2.2 Control and Instrument Systems

The information in this section of the reference ABWR DCD, including all subsections, tables, and figures, is incorporated by reference with the following departures.

Figure 2.2.1 Rod Control and Information System Control Interface Diagram

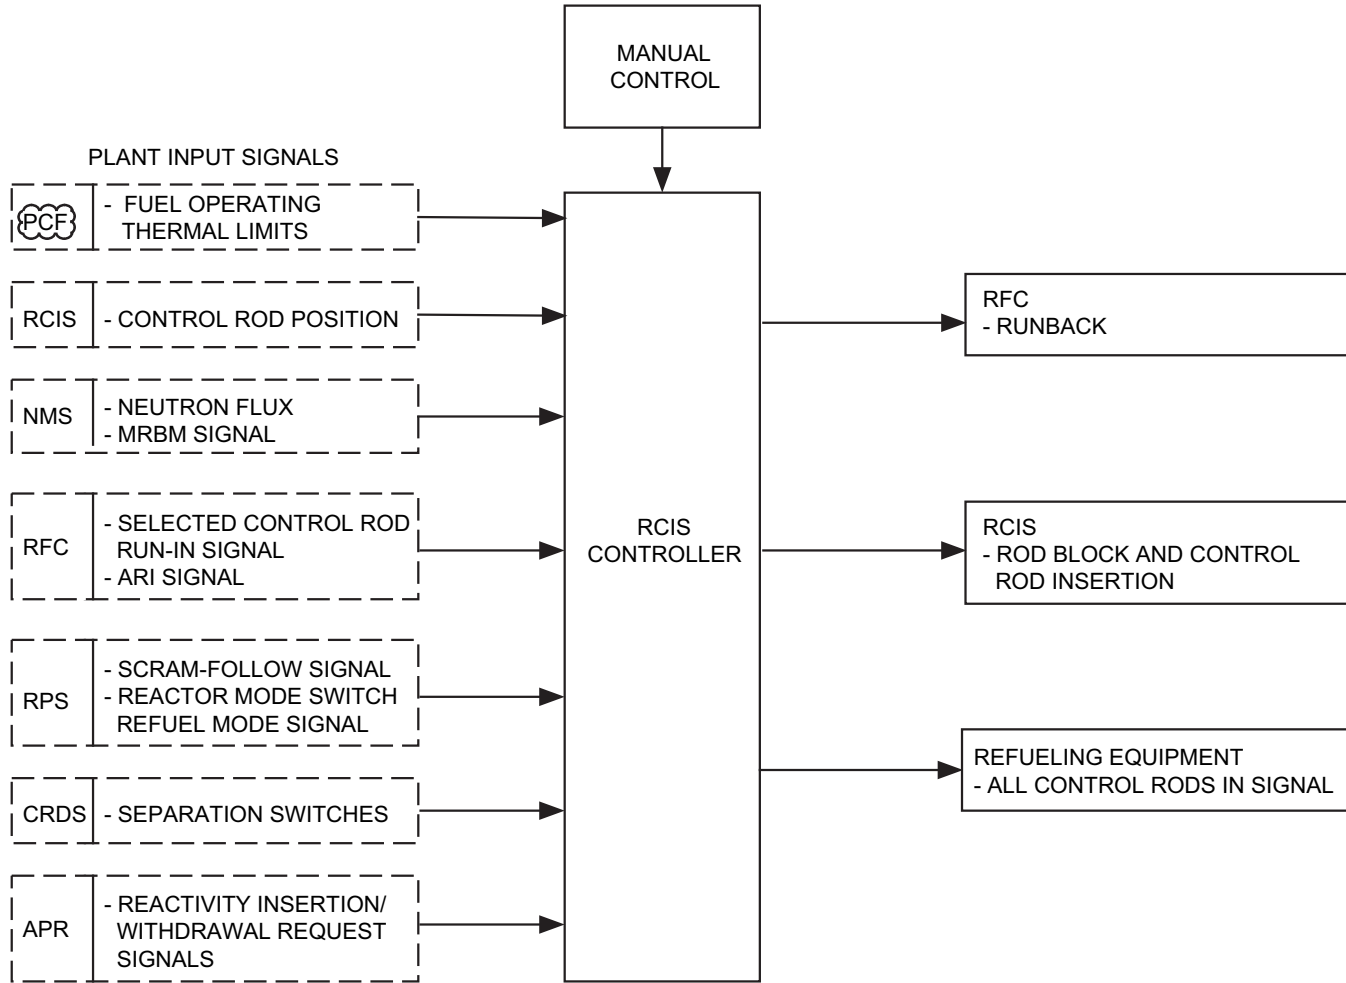
STD DEP T1 3.4-1 (Figure 2.2.1)

NOTE:
1. INTERCONNECTIONS MAY BE FIBER-OPTIC OR METALLIC.

Figure 2.2.5 Neutron Monitoring System

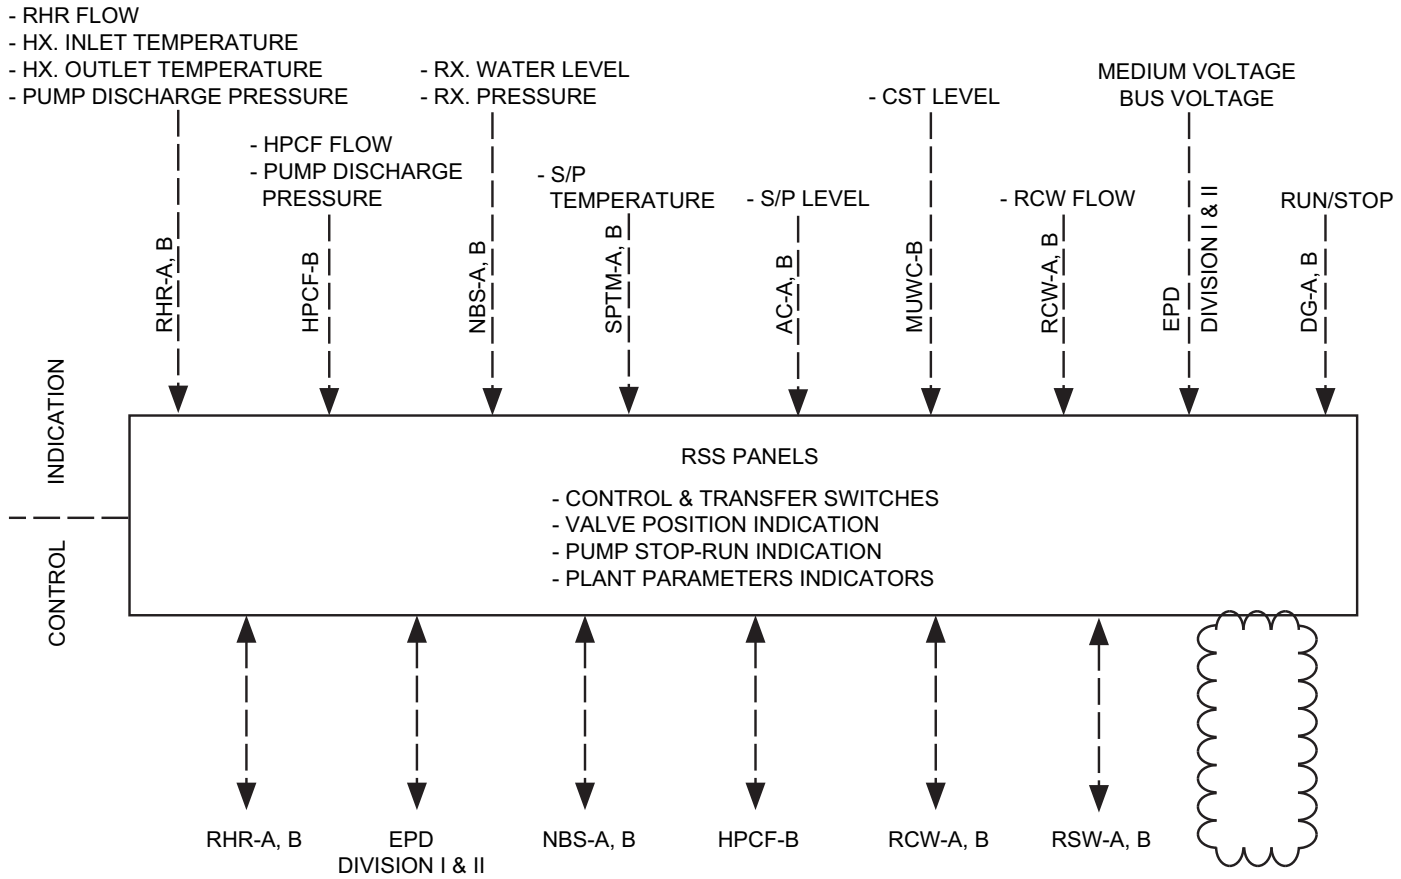
STD DEP T1 3.4-1 (Figure 2.2.5)

1. DIAGRAM REPRESENTS ONE OF FOUR NMS DIVISIONS (MRBM IS A DUAL CHANNEL SYSTEM. THERE IS ONLY ONE IN-CORE INSTRUMENT CALIBRATION SYSTEM).
2. USED FOR RAPID CORE FLOW DECREASE TRIP.
3. SRNM AND APRM ATWS PERMISSIVE SIGNALS TO SSLC.
4. INTERCONNECTIONS MAY BE FIBER-OPTIC OR METALLIC.

Figure 2.2.7b Reactor Protection System

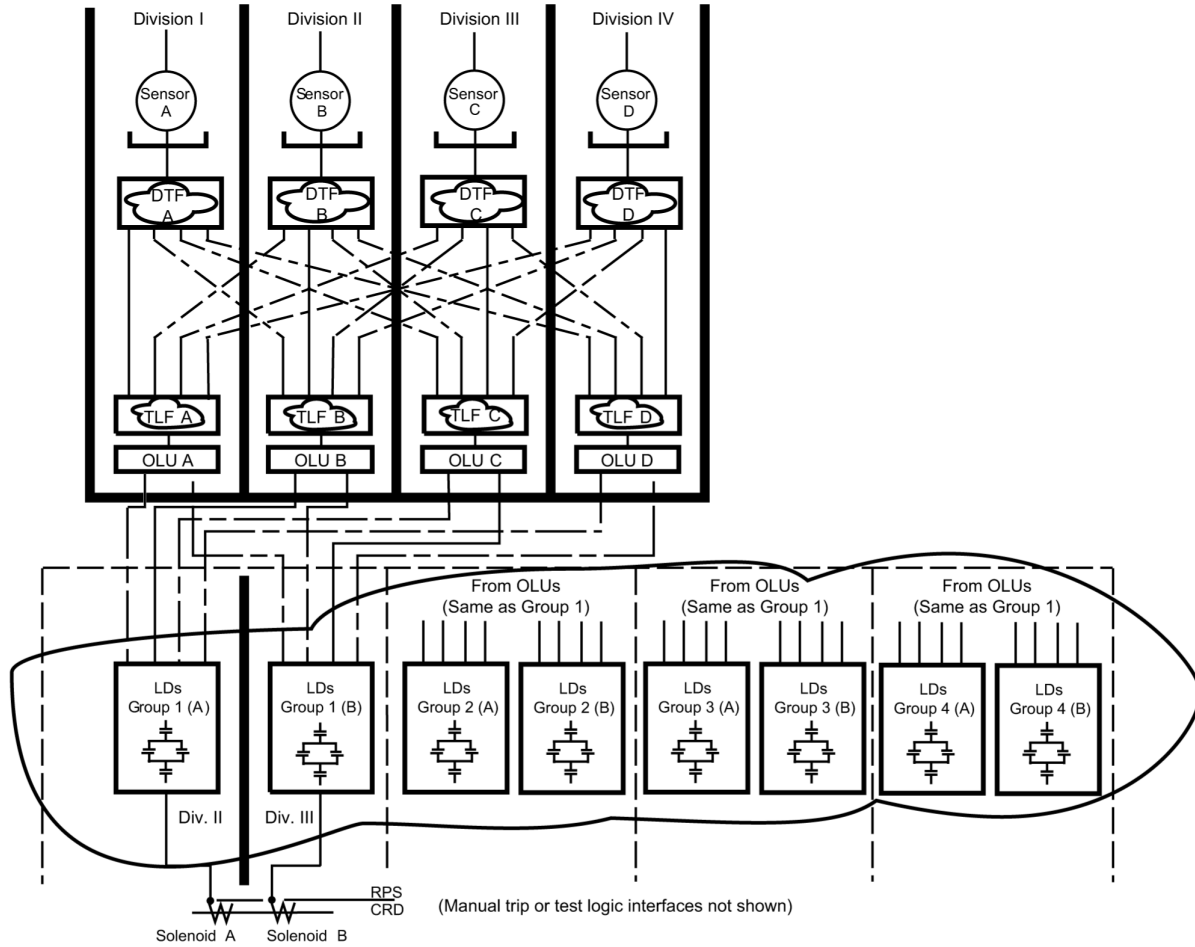
STD DEP T1 3.4-1 (Figure 2.2.7b)

The RPS has four divisions. Figure ~~2-2.6a~~ 2.2.7b shows the RPS divisional aspects and the signal flow paths from sensors to scram pilot valve solenoids. Functions Equipment within an RPS division consists of include sensors (transducers or switches), I/O, ~~multiplexers,~~ data communication, digital trip ~~modules~~ functions (DTM DTF), trip logic unit function (TLU TLF), output logic unit (OLU), and load drivers (LD). The LDs are only in Divisions II and III. The (DTF) and (TLF) are performed in digital configurable logic devices. The data communication functions are described in Section 2.7.5.
